**The Scottish Government
Energy Consents Unit**

**Scoping Opinion on behalf of Scottish Ministers under the Electricity
Works (Environmental Impact Assessment) (Scotland) Regulations 2017**

**Earba Pumped Storage Hydro Scheme
Earba Storage Ltd.**

27 April 2023

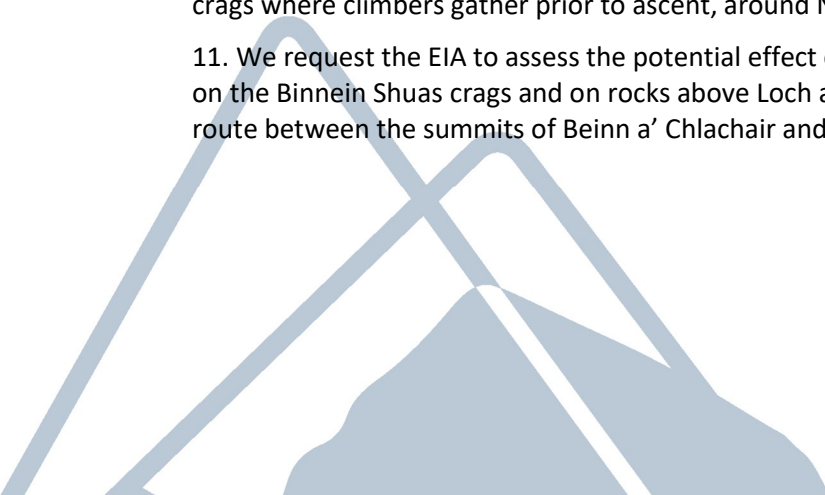
8. Given the popularity for climbing and hillwalking in this area we request that the applicant produce an Access Management Plan for construction traffic and recreational users. From our mountaineering perspective we note the following as key matters that we would wish the applicant to address:

- i. The shared access route across the bridge over the River Spean and following the existing track to Lochan na h-Earba.
- ii. Route and construction of the proposed new footpath south-west of the loch (indicative route).

- iii. Maintenance of access during construction along the north side of Lochan na h-Earba to the climbing crags of Binnien Shuas – this is an informal route that currently leaves the main track at the head of Loch Earba and will need realignment as approximately the first third of it will be in a proposed inundation zone.
